**KNOXVILLE HISTORIC ZONING COMMISSION
STAFF REPORT - CERTIFICATE OF APPROPRIATENESS APPLICATION**

PROPERTY ADDRESS: 118 E Jackson Ave

FILE NO.: 10-F-15-HZ

MEETING DATE: 11/19/2015

JACKSON AVENUE DEMO EAST ELEVATION
SCALE 3/8" = 1'-0"

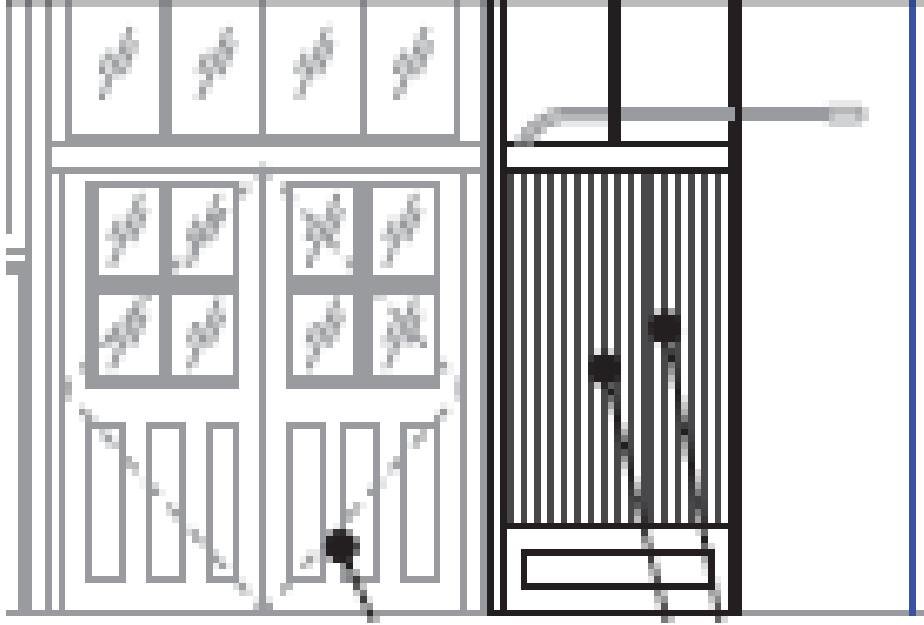
- 1) The wood slat utilities screen will not be permanent part of the structure and will help to obscure the utility meter panel on the front of building 118.

- 2) The metal roll-up door at 118 is not original, and although no documentary photos have been found, the filling of the opening with storefront to match the existing is an appropriate and will be more pedestrian friendly by making the façade more transparent. No historic material will be destroyed.

- 3) The early metal cornice on 108 to be removed is highly deteriorated, but its scale and design are appropriate. The new wood cornice will match the profile of the metal one since no documentation has been found exhibiting the design of the original cornice. This is the only historic fabric to be removed.

- 4) The wood door at 118 is not original, but the style is appropriate for the building, so the new door will be similar to the existing.
- 5) No currently unpainted brick will be painted.

Approval
